**UN Global Technical Regulation No. 9 (Pedestrian safety):**

**Proposal for Amendment 4**

**Submitted by the Chair (Republic of Korea) of the Informal Working Group on the Deployable Pedestrian Protection Systems of UN Global Technical Regulation No. 9. \***

Figure XY  
Detection Area Width

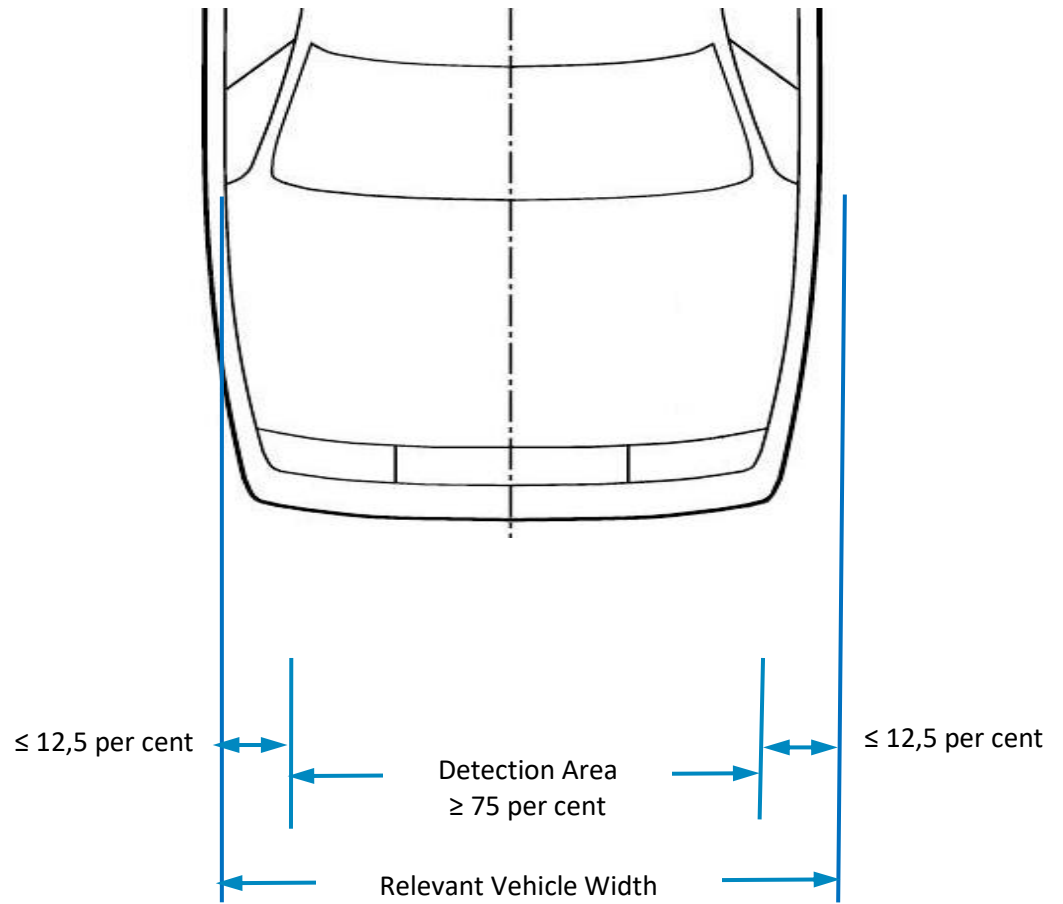
- 3.19.1. ["Deployed position" means the position of the vehicle outer surface equipped with a DPPS that can be maintained by the system after its activation. For a static test, the Deployed position shall be specified by the manufacturer.]
- 3.19.2. "Un-deployed position" means the position of the vehicle outer surface equipped with a DPPS when the DPPS is not activated.
- 3.20. "Detection area" is the area designated to detect a pedestrian in order to initiate the activation of the deployable system. The width of the detection area shall be the relevant vehicle width, minus a distance from each side of max of 12,5 per cent of the relevant vehicle width, but not more than 250mm. The detection area must not be smaller than the bumper test area (BTA) as defined in paragraph 3.12.1. [The detection area must not be smaller than the area between the corners of bumper - 42mm.]

Figure 1  
Scheme of different test configurations

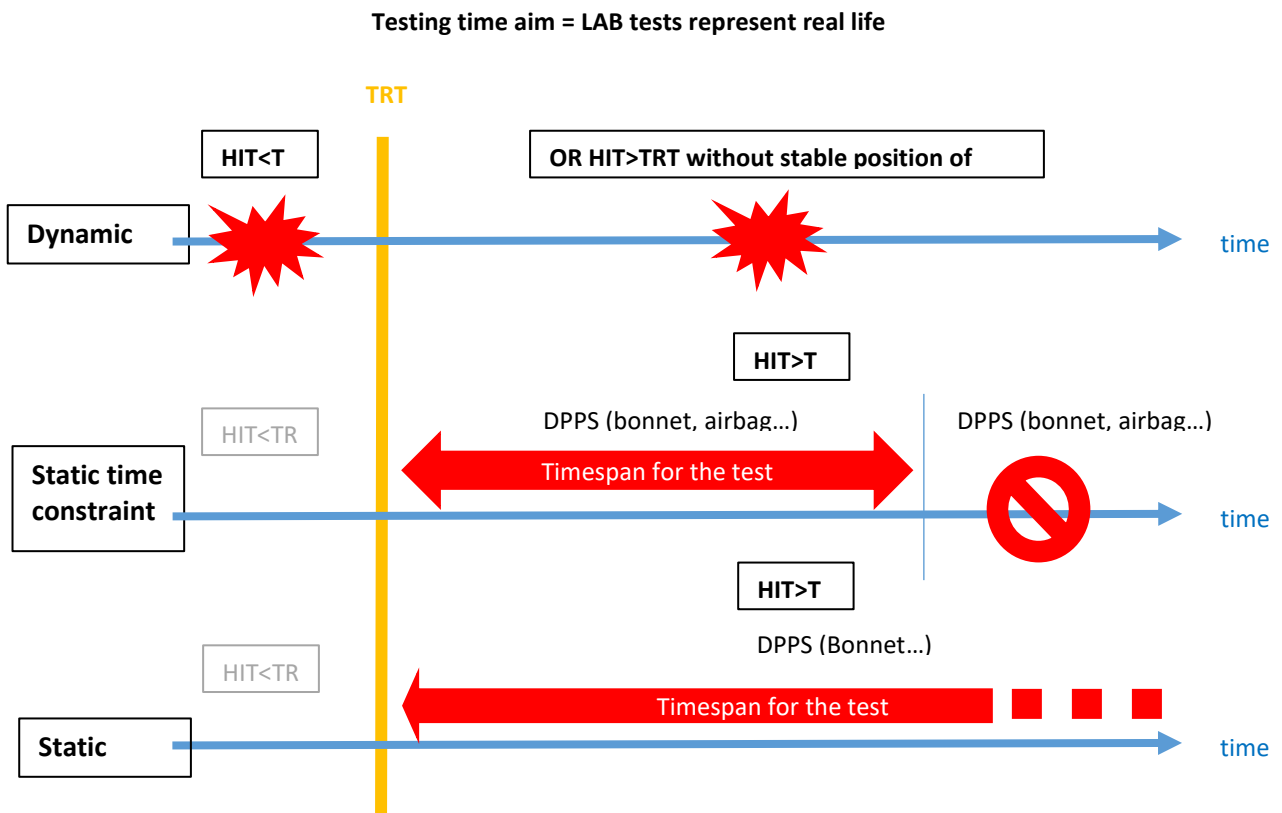
With this information (evolution of system stability) and Fig. 1, a decision can be made on how to perform the test. During the static tests it shall be ensured that the resisting force of the DPPS is equivalent to the actual situation at the real HIT.

Figure 2  
Scheme of detection area subdivision

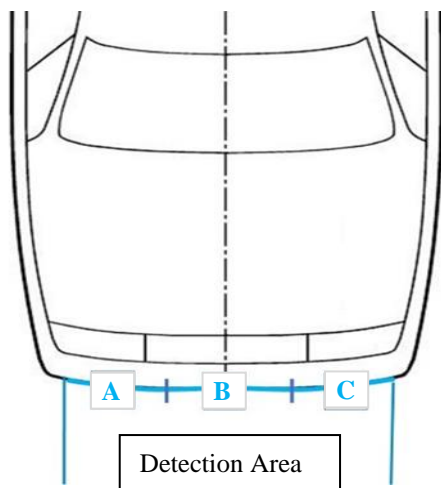
- 1.6. Sensing System Verification**
- 1.6.1.** The detection area for the activation tests as specified in paragraph 1.6.4. of Annex 1 is defined in paragraph 3.20. of this Regulation.
- 1.6.2.** The detection area will be subdivided into three thirds of identical width, whereas one third is the geometrical trace between the left and right end of the detection area, measured with a flexible tape following the outer contour of the bumper at the upper bumper reference line, equally divided by three. See Figure 2 below.<sup>1</sup>

Figure 3  
Flowchart DPPS Assessment

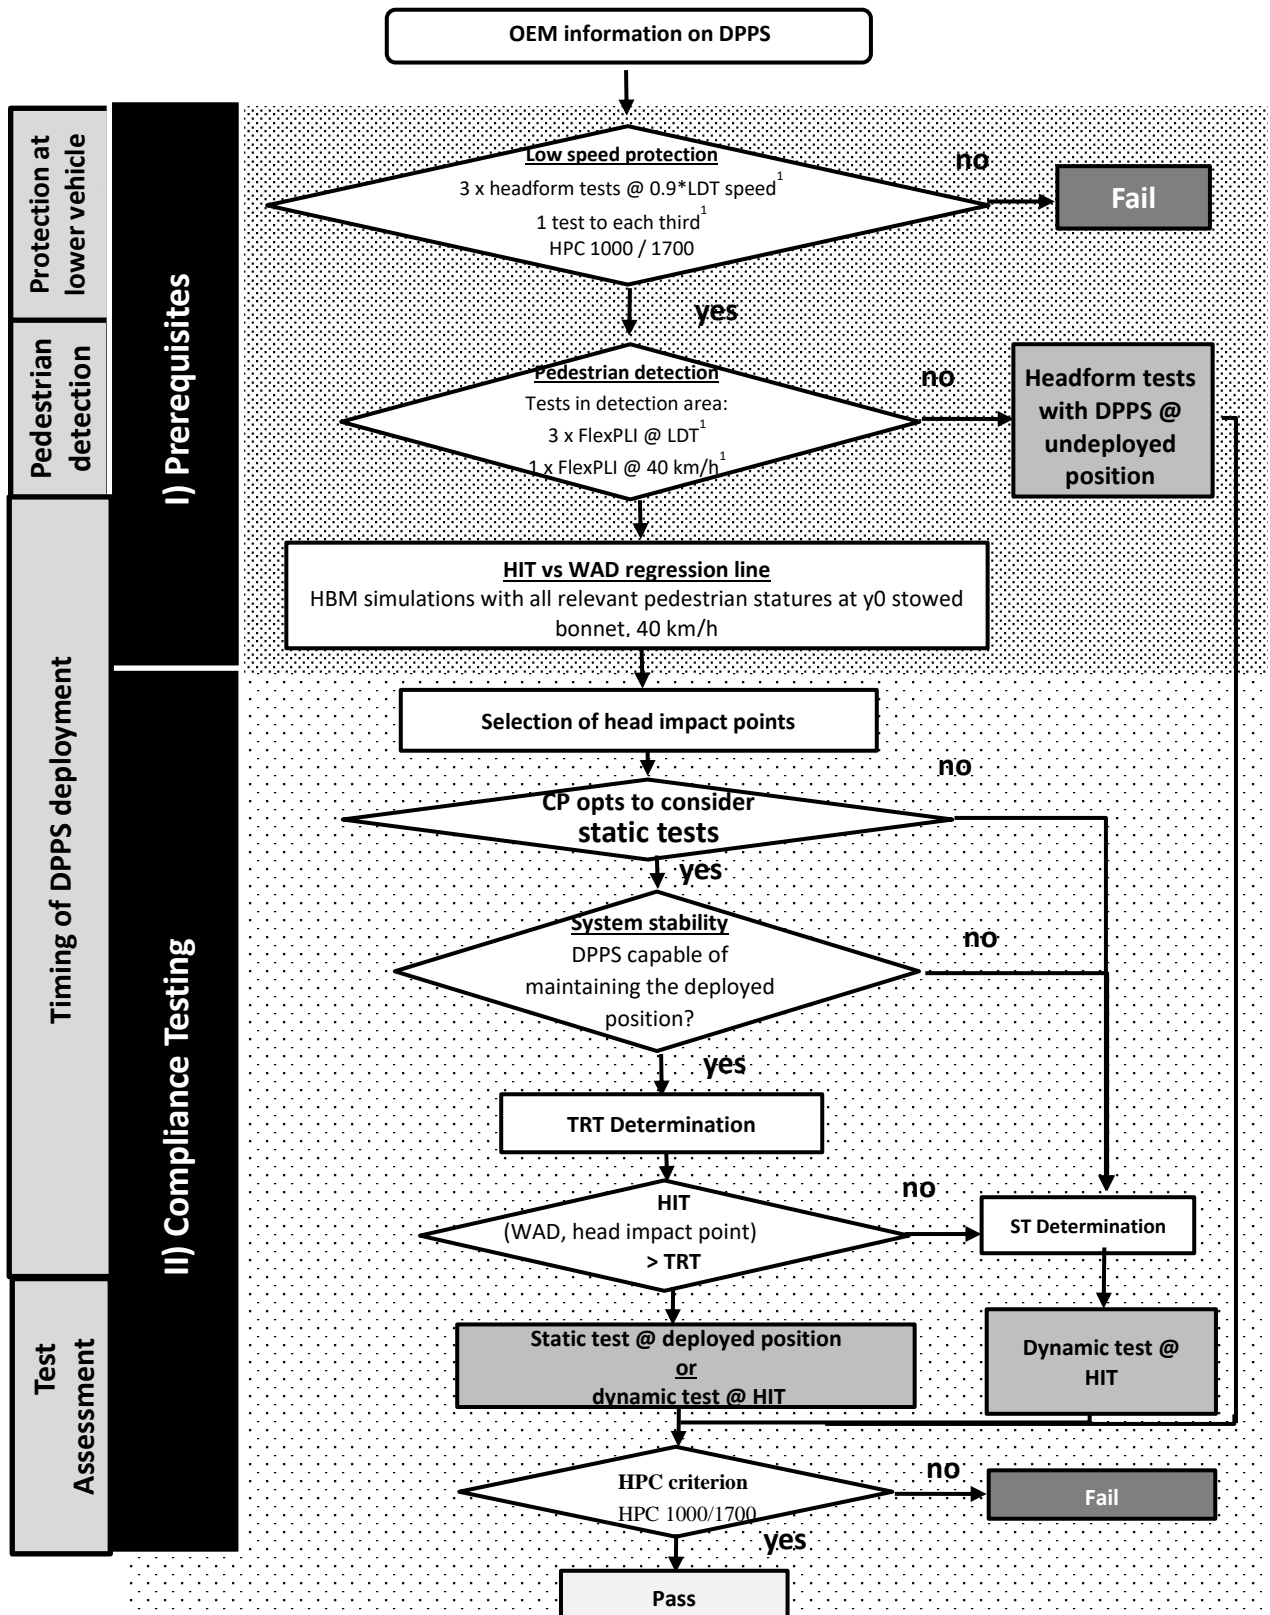
The flowchart in Figure 3 illustrates the decision process for Contracting Parties that allow both static and dynamic options. For Contracting Parties that allow only dynamic option, this flow chart is also useful, but not all steps will be considered.

Figure 4  
Scheme of HIT vs WAD for combined testing]

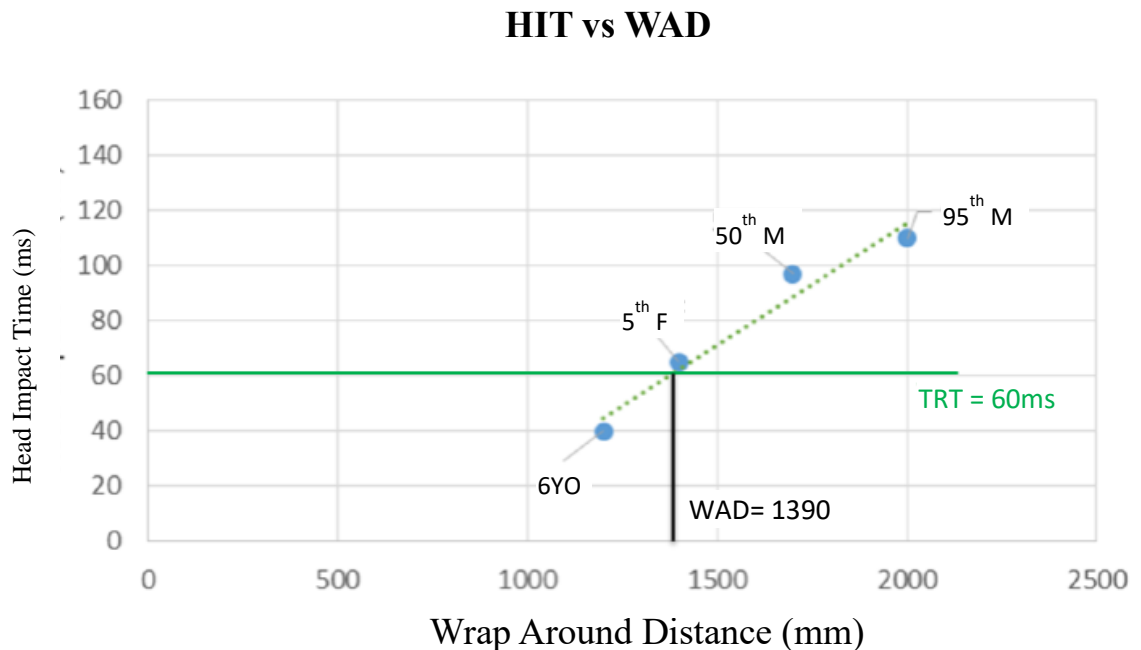
- [5.3. "Combined" test option:
- If the bonnet top test area consists of sections where the HIT at the impact point WAD is less than TRT ( $HIT < TRT$ ) as in paragraph 5.2.2. of Annex 1 and sections where the HIT at the impact point WAD is greater or equal than TRT ( $HIT \geq TRT$ ), as in paragraph 5.1.1.1.1. of Annex 1, then all test points forwards of the corresponding wrap around distance WAD ( $HIT < TRT$ ) shall be tested dynamically. The remaining section of the bonnet top test area may be tested statically. The undeployed marking procedure shall be used for this combined option. (see Figure 4 below).
